## Product Change Notice (PCN)

PCN Number: **PCN-0451205R-01**

Product(s) Affected: *PJ-057BH*

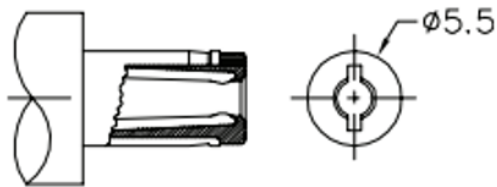
Description of Change: *Minor Housing and footprint differences. Material Change on the housing and terminals. See image Below*

PREVIOUS CUI DEVICES DETAIL / IMAGE			NEW CUI DEVICES DETAIL / IMAGE		
	MATERIAL	PLATING	DESCRIPTION	MATERIAL	PLATING/COLOR
center pin	copper	nickel	center pin	brass	nickel
terminal 1	brass	silver	terminal 1	brass t=0.40	silver
terminal 2	copper alloy	silver	terminal 2	bronze t=0.30	silver
terminal 3	brass	silver	terminal 3	brass t=0.40	silver
plastic	PBT		cover	PA10T (UL94V-0)	black
			housing	PA10T (UL94V-0)	black

MATING PLUG  
Jack Insertion Depth: 9.15 mm

MATING PLUG  
Jack Insertion Depth: 9.45 mm
